Subject: Duke Energy Carolinas, LLC (Duke Energy)
Oconee Nuclear Station, Units 1, 2, and 3
Docket Numbers 50-269, 50-270, and 50-287
Response to NRC RAI regarding 10 CFR 50.46 Notification of Change in
Peak Cladding Temperature for Large Break Loss of Coolant Accident
Analysis

**RESPONSE TO NRC RAI REGARDING 10 CFR 50.46
NOTIFICATION OF CHANGE IN PEAK CLADDING
TEMPERATURE FOR LARGE BREAK LOSS OF COOLANT
ACCIDENT ANALYSIS**

177 Fuel-Assembly Plant RAI Responses to a 30-Day 50.46 Report of Significant PCT Change

ANP-3180
Revision 1

Figure 3-1: 177-FA LL 2.506-ft BOL LBLOCA RELAP5 Analysis,

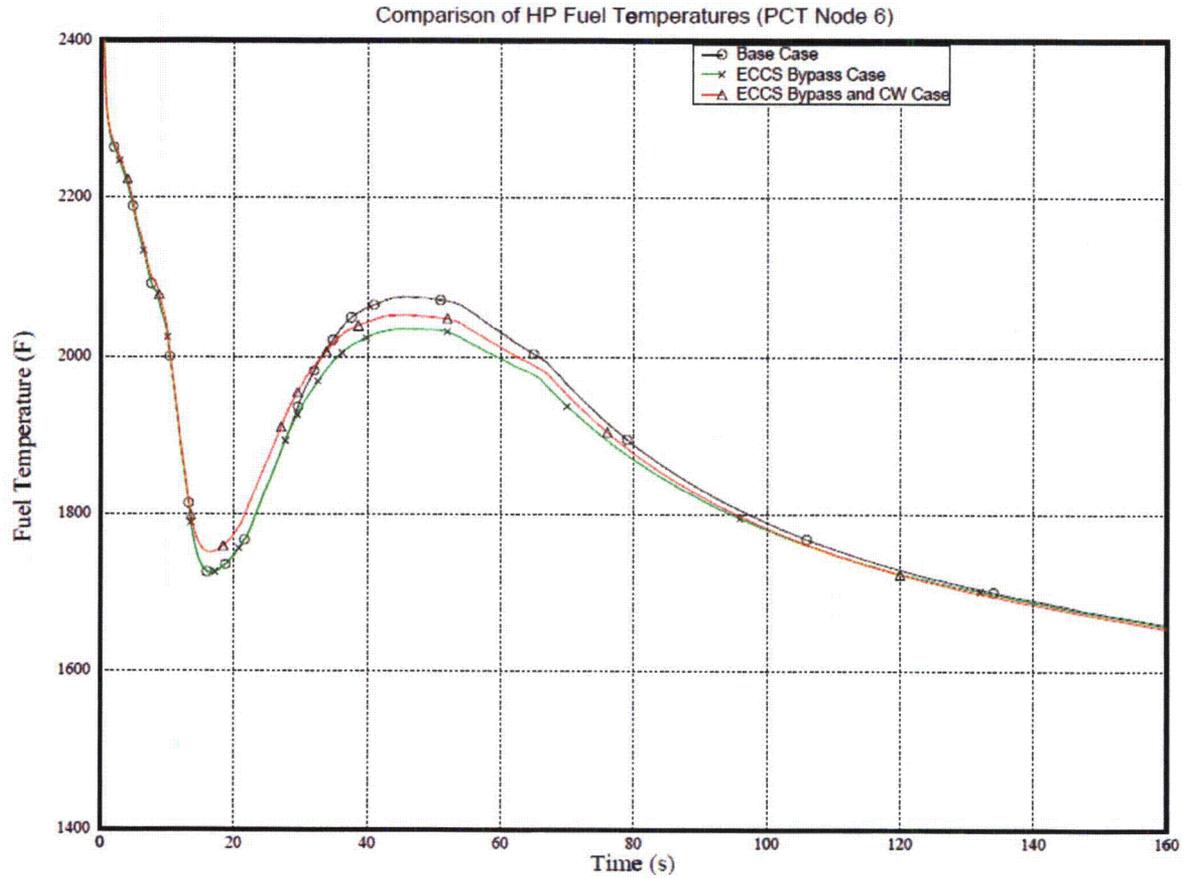
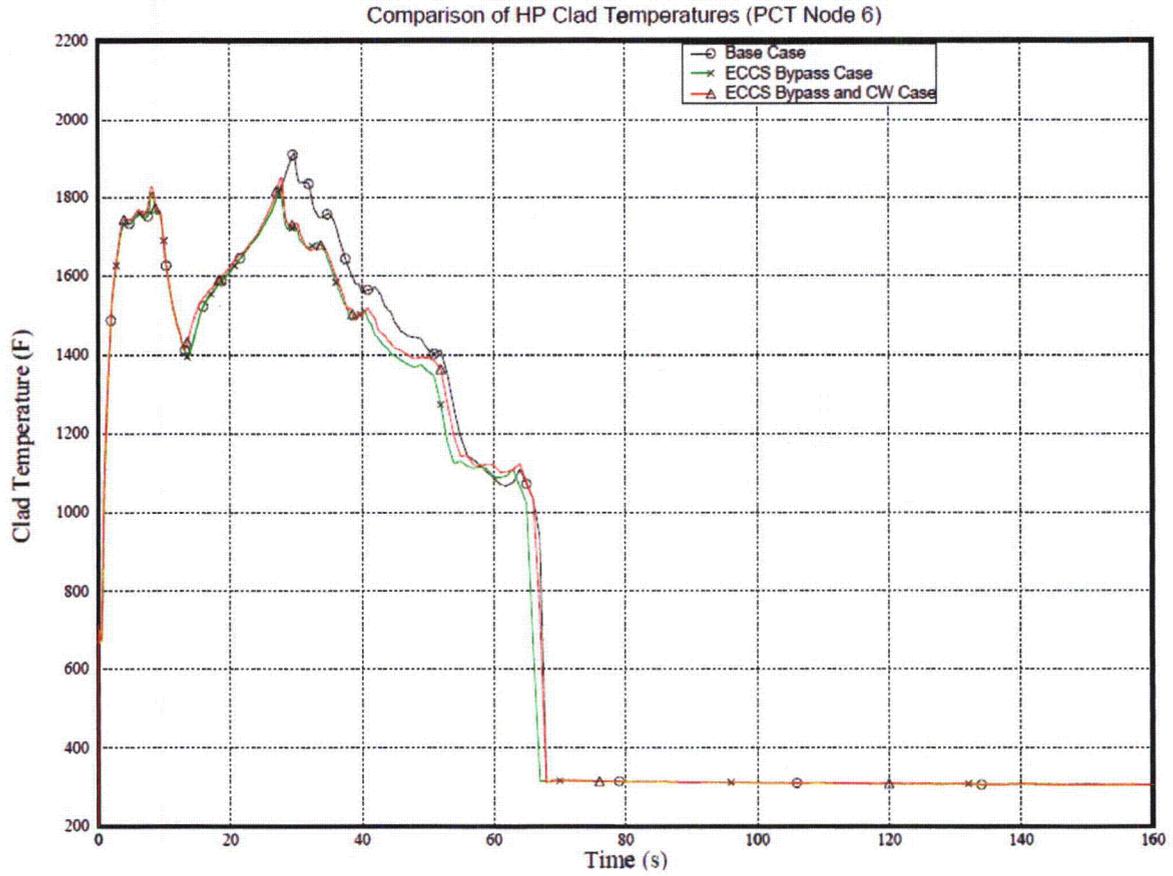
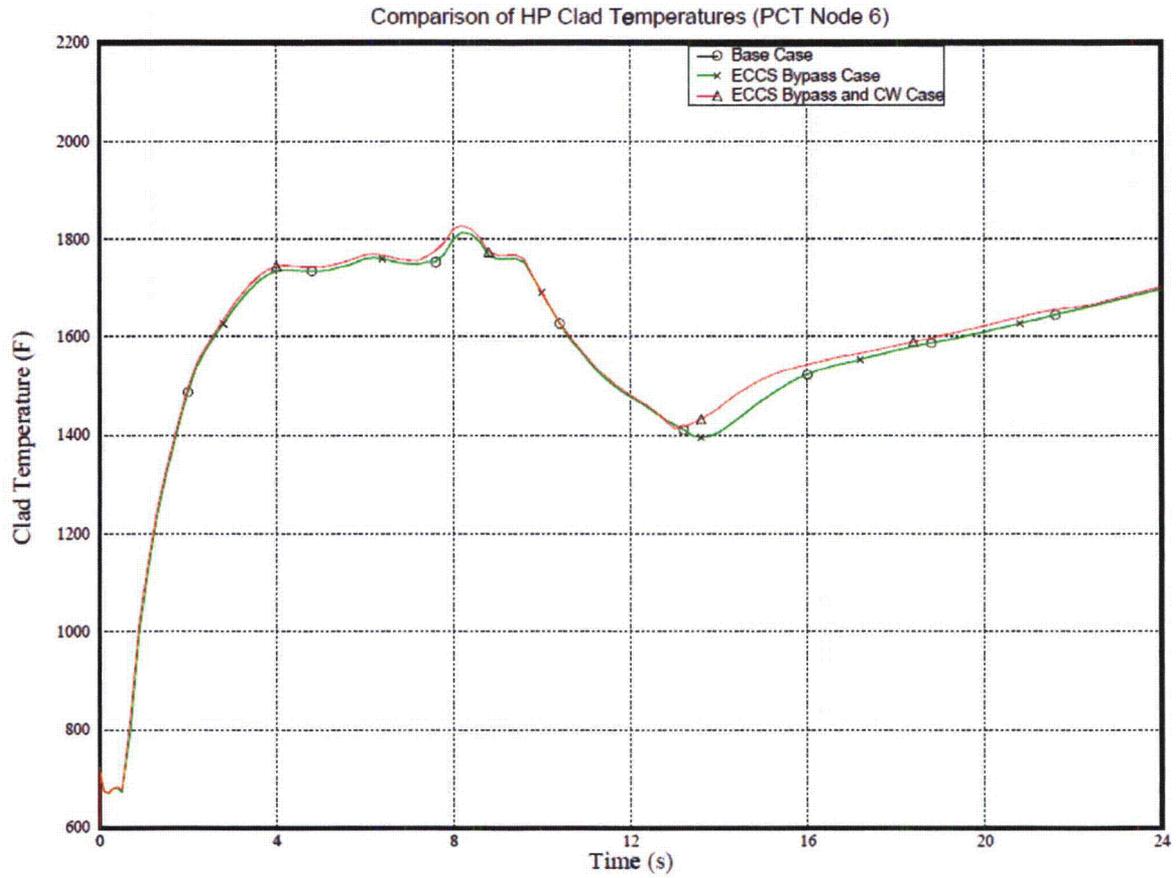
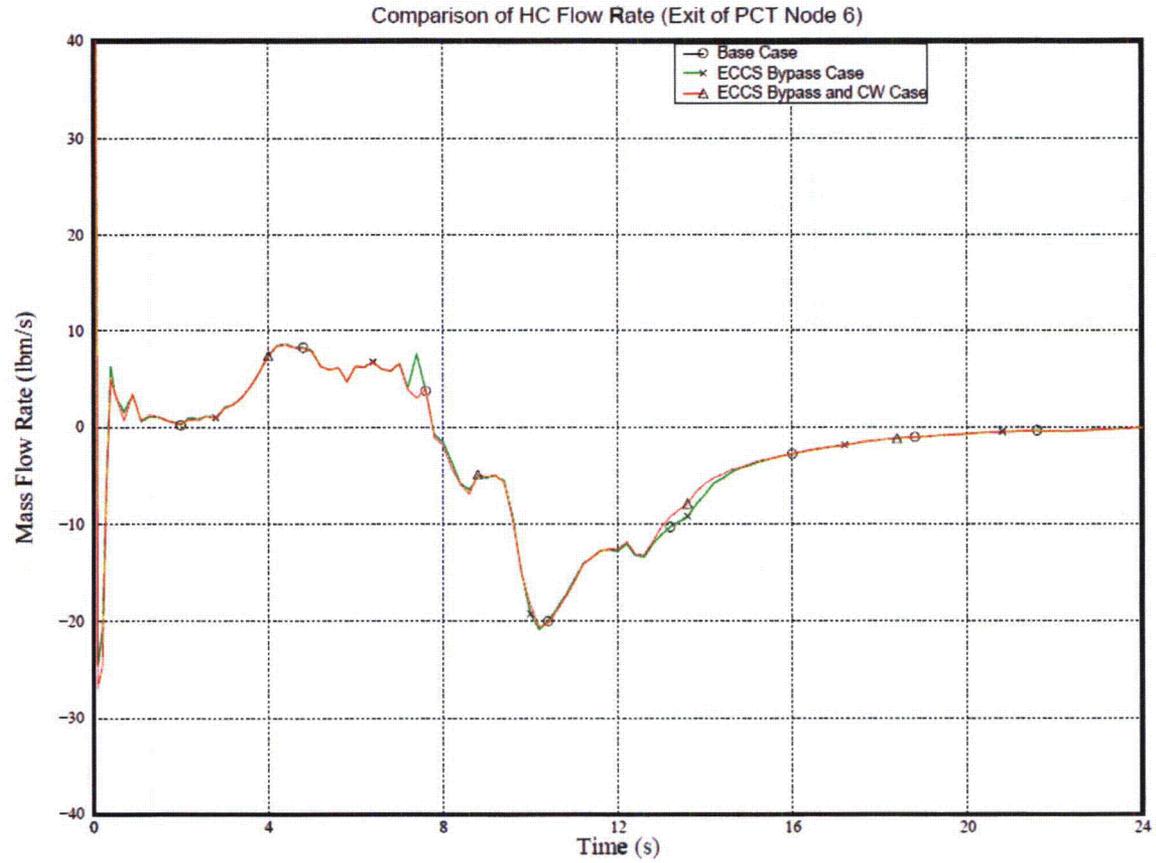
- 1. There are two changes to peak cladding temperature (PCT) for Large Break Loss-of-Coolant Accident (LBLOCA) analysis discussed in the report submitted by the licensee. The first change is an Evaluation Model (EM) application error in the determination of the end of Emergency Core Cooling System (ECCS) bypass, which resulted in an 80 F decrease in PCT. The second change is an EM modeling change to include the effects of the upper plenum column weldments, which resulted in an 80 F increase in PCT.*

Provide the analysis that lead to each change having an 80 degree change in PCT.

Some key comparison plots were generated for the 177-FA LL plants in Figure 3-1, Figure 3-2, Figure 3-3, and Figure 3-4. Each figure shows the results for three cases:

- 1) The base model with the ECCS bypass error and no CWs,
- 2) The corrected ECCS bypass result (no separate CWs modeled), and
- 3) The corrected ECCS bypass with CWs.

Figure 3-1 provides the fuel volume-average temperature for the limiting PCT location, while Figure 3-2 shows the ruptured cladding temperatures at the limiting PCT location for the entire LBLOCA transient. In these analyses, the reduction in fuel temperature and PCT from the ECCS bypass correction begins around 28 seconds (time of BOCR) versus the base case. The ECCS bypass case fuel and cladding temperatures are lowest near the PCT time. The ECCS bypass and CW case (3) is in between the base case (1) and the ECCS bypass case (2).

The cladding temperatures from the PCT location are shown in Figure 3-3 for the blowdown and early reflood period. In this plot, the base case and the ECCS bypass case have identical cladding temperatures. The CW study shows that the temperatures remained similar during the first 7 seconds, which is during the core up flow period. Some larger temperature differences are observed in around 7 and then again at 13 seconds. These temperature changes are associated with variations in core flow near the time when the core flow reverses or during the reverse flow period shortly after the CFT flow and its condensation begins. Figure 3-4 provides the HC hot spot flow for the blowdown and early reflood period to confirm the cladding temperature changes are associated with the core flow variations.

Figure 4-1: Simplified Column Weldment Drawing

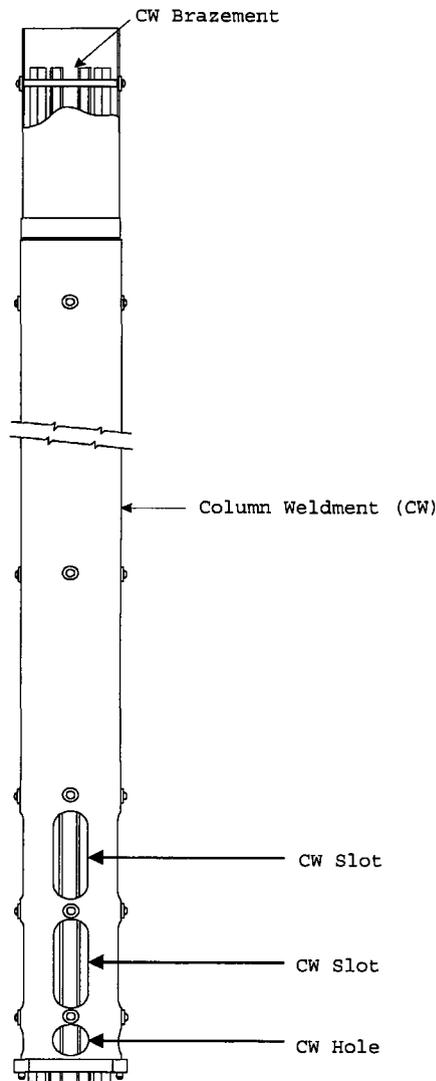
- a. *Provide justification to show that analyzing column weldments modeled for a 177 FA plant has an effect on PCT of the same magnitude in a lowered loop plant as in a raised loop plant.*
- b. *Describe the nodalization for the column weldments used in the RELAP5 analyses.*
- c. *Provide simplified drawings to compare the column weldment design for a 205 FA plant to the column weldments for the 177 FA plant.*

A simplified drawing of the column weldments is shown in Figure 4-1. The column weldments for the 177-FA plants and 205-FA plants are similar. Table 4-2 provides some relative comparative ratios of select parameters rather than proprietary dimensions.
